HISTORIC PRESERVATION COMMISSION STAFF REPORT

Address:	7120 Carroll Ave., Takoma Park	Meeting Date:	02/08/17
Resource:	Contributing Resource Takoma Park Historic District	Report Date:	02/01/17
Applicant:	Kamau Amen (Trevor Hogan, Agent)	Public Notice:	01/25/17
Review:	HAWP	Tax Credit:	n/a
Case Number:	37/03-171	Staff:	Dan Bruechert
Proposal:	Solar panel removal and re-installation

MONTGOMERY COUNTY HISTORIC PRESERVATION COMMISSION
STAFF REPORT

Address:	7120 Carroll Avenue, Takoma Park	Meeting Date:	3/26/2014
Resource:	Contributing Resource Takoma Park Historic District	Report Date:	3/19/2014
Applicant:	Kamau Amen (Katie Hinkle, Agent)	Public Notice:	3/12/2014
Review:	HAWP [RETROACTIVE]	Tax Credit:	N/A
Case Number:	37/03-14D	Staff:	Josh Silver
PROPOSAL: Solar panel installation

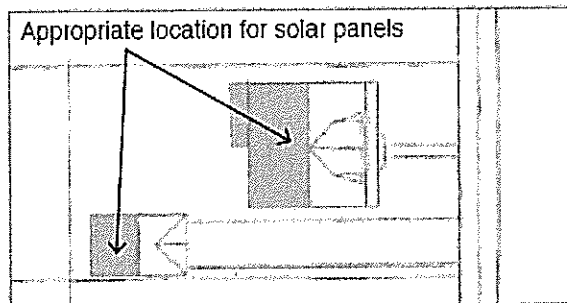
In contrast to the proximity of the building to the left (west) of 7120 Carroll Ave., a driveway and large gravel parking lot to the right (east) make the entirety of the right (east) elevation of the building highly visible. This creates a situation where changes that occur on the right (east) side of the subject building have a more significant visual impact on 7120 Carroll Ave. and the surrounding district than changes to the left (west). While the right (east) elevation is a secondary elevation, changes to it will be highly visible and more consideration should be given the impact proposed changes will have on the surrounding district.

Figure 1: East side of 7120 Carroll Ave., note the highly visible nature of the elevation

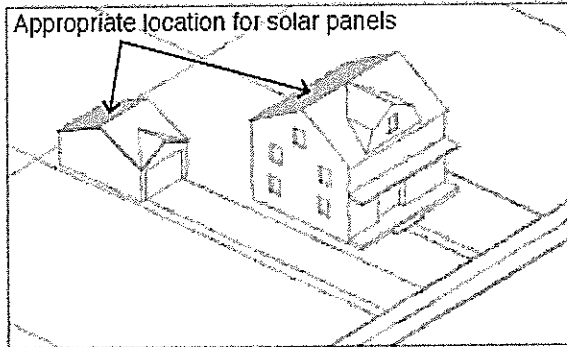
Figure 2: West elevation of 7120 Carroll Ave., the proximity of 7118 Carroll mitigates the appearance of the solar panels.
